THE PARK HABITAT PROJECT, SAN JOSE, CALIFORNIA
DESIGN GUIDELINES AND STANDARDS
COMPLIANCE REVIEW

DRAFT

APRIL 7, 2021

Figures 1 and 2. Proposed site plan (left) and the Park Avenue façade (right). Kengo Kuma & Associates and Adamson Associates, Inc., February 26, 2021.

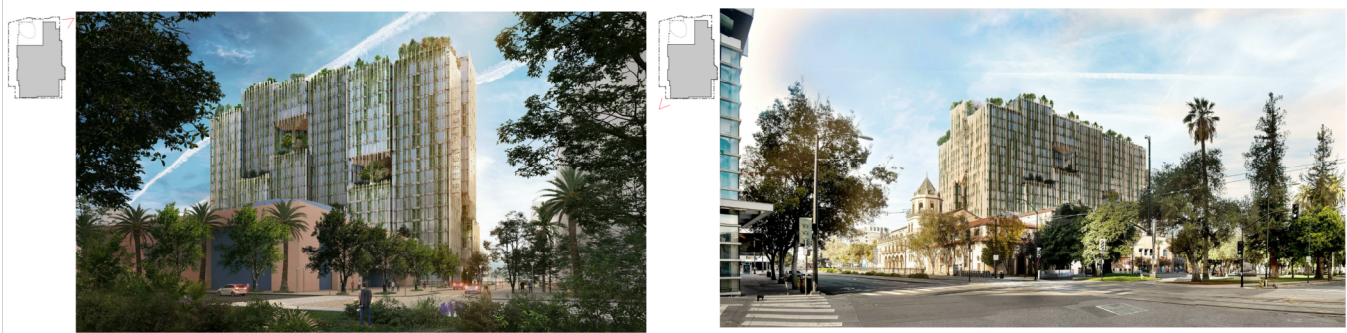
The proposed project is a mixed-use development, comprising of 20 stories plus a roof deck above grade and four stories of parking below grade. The program is predominantly office space with retail space located on levels P1, and 1. Additional commercial space is located on level 20. Expansion space for The Tech Interactive museum is located on levels 1 and 2, adjacent to the existing museum building. The underground parking entrance and loading dock are located at the south end of level 1, accessible from Almaden Avenue.

The building design features a full-height courtyard, referred to by the design team as the "green lung," which brings daylight and natural ventilation to the interior of the office floor plates. The main office lobby is accessible from Park Avenue and the pedestrian walkway, or the paseo, and is connected to the bottom of the "green lung." The "green lung" is open to the exterior at levels 1-3, 6-8, 9-11, and 12-14.

The project includes the landscape design of the paseo on the west side of the site, and a pedestrian plaza at the corner of Park Avenue and the paseo. A sloped landscape with an accessible path forms a connection between the sidewalk and the program on level P1, which will include short- and long-term bicycle parking, retail, and valet parking. A constructed wetland is also included in the at-grade landscape. Additionally, the building design features 15 elevated, landscaped terraces at various heights above grade. The majority of the roof is covered with a sloping, heavily landscaped garden.³
